RE: Technical Revision 38 Adequacy Review Responses, Permit M-1977-348

**Re: Henderson Mine, Permit No. M-1977-342, Technical Revision TR-04 Partial Approval,
Ultimate Canal As-Built Drawing and Post Construction Certifications**

Re: Ultimate Canal As-Built Certification

Re: **#1333.16** ***Henderson Ultimate Canal
Hydrologic Design Basis***

Henderson Ultimate Canal System	
General Arrangement	
Site Plan

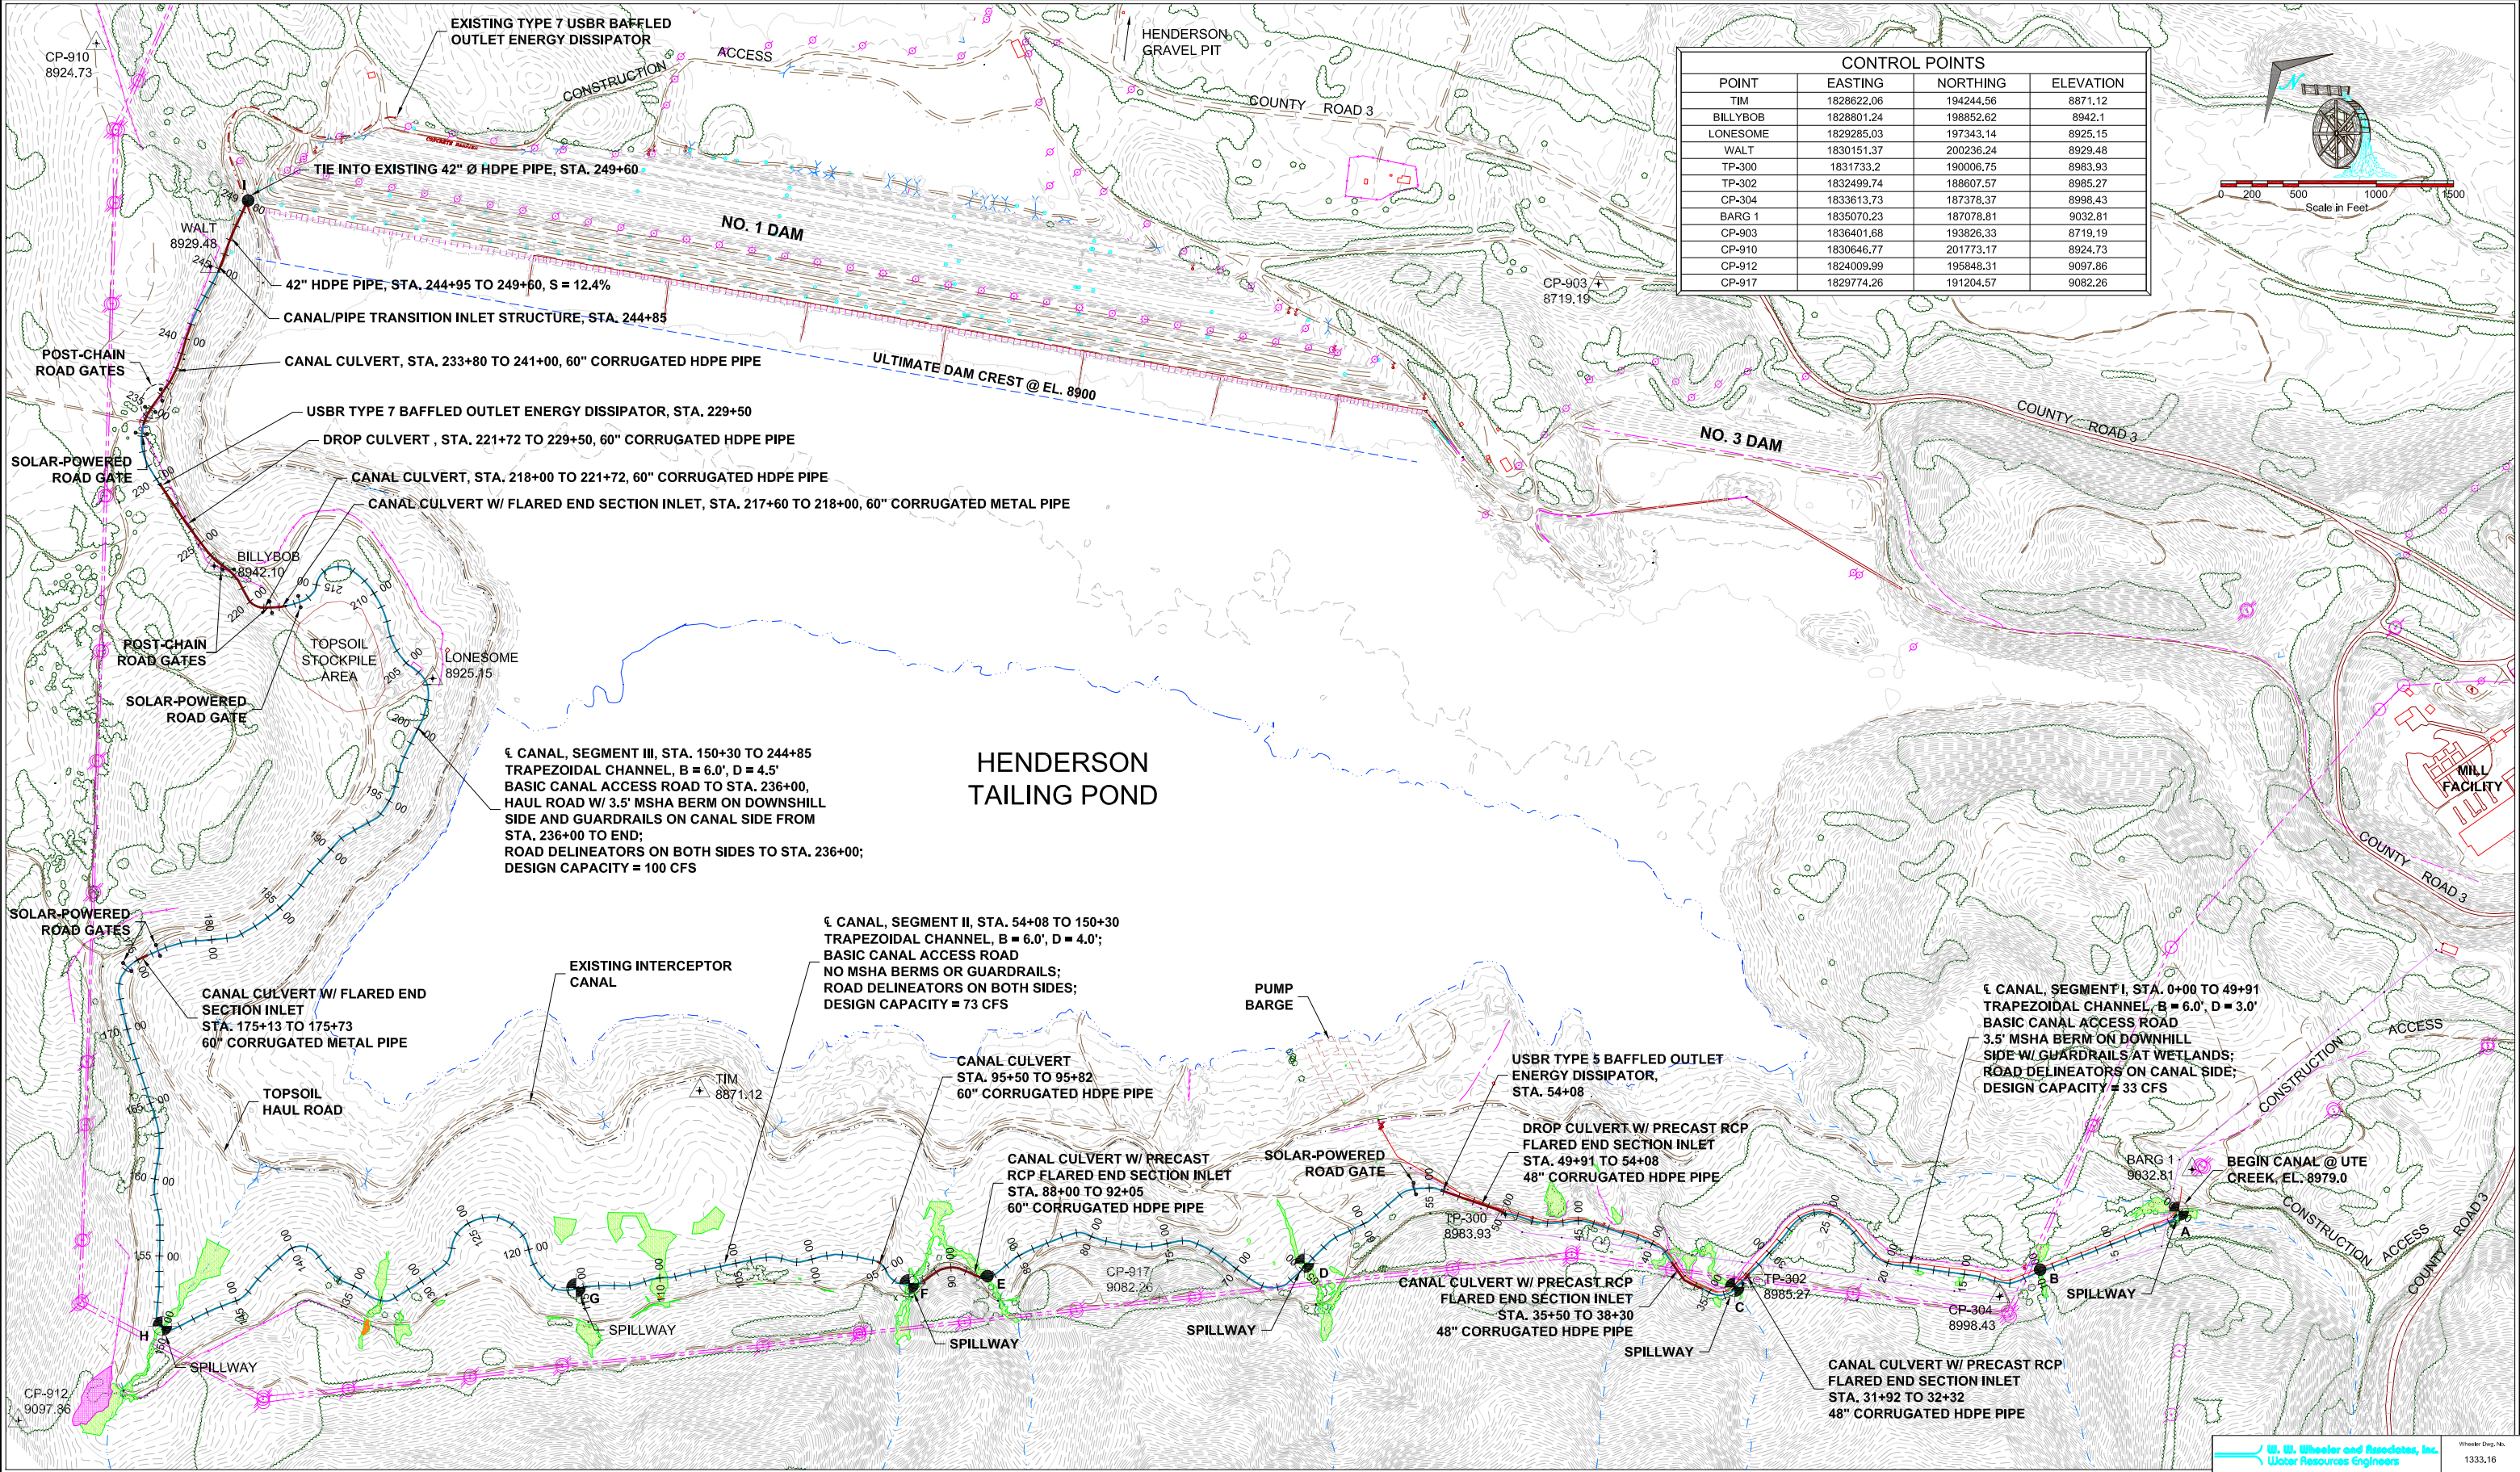
full operation in 2010 when the lower canal became inundated by the TSF. An as-built survey was conducted in September 2010 and Wheeler personnel performed a site walk-through in September 2011 to document changes that have been implemented following the 2007 phase of construction. The current configuration of the canal system is shown on Drawing UC-1-01 Rev4, which is a revised version of the original record drawing.

Flow Diagram

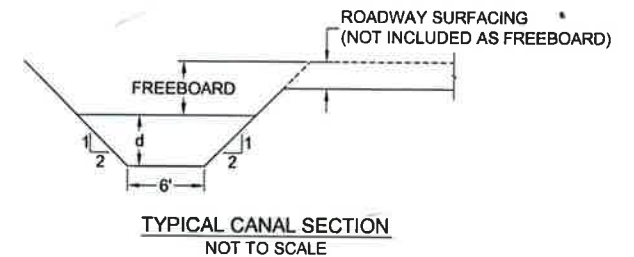
Thanks for the quick response, Ron. Can you direct me to a hydrology study (or other documentation) that includes an analysis of the 200-year snowmelt flood and the source of the 100 cfs value?

Thank you for submitting the response. Our engineer reviewing it said the hydraulic analysis looks good. We have one follow-up question on item #1. Where did you get the value of 100 cfs for a design flow for the Ultimate Canal System?

I can't tell if this report was provided back in 2012 during TR-04, that was a bit before my time. Please see the Ultimate Canal Hydrologic Design basis that outlines the 200-year snowmelt with extra conservatism added into the design. The 200-year flood resulted in a flow rate of 64 cfs at the end of the canal. The canal was designed with a 1.5 factor of safety to bring it to 100 CFS at the end as shown on drawing UC-1-01. You will note in the report that the Ultimate Canal was assumed to fail temporarily during the PMP event from the 2005 study, which is the same assumption in the updated report provided in TR-38.

The design capacity of the Ultimate Canal system is based on safely conveying the 200-year snowmelt flood around the tailing storage facility (TSF) without compromising the integrity of the canal or the TSF itself. The canal system includes five spillway structures strategically located along the canal alignment. The intent of the spillway structures is to divert water into the TSF decant pond if the actual canal flows exceed the design capacity. The flow requirement varies across the canal's length depending on the inflow basin size, but at this section is 100 CFS (compared to 33 CFS between spillway A and B on the upper portion of the Canal). This is shown on Drawing UC-1-01 of the as-built that were submitted as a part of the EPP in TR-04. Let me know if you would like me to resend that.
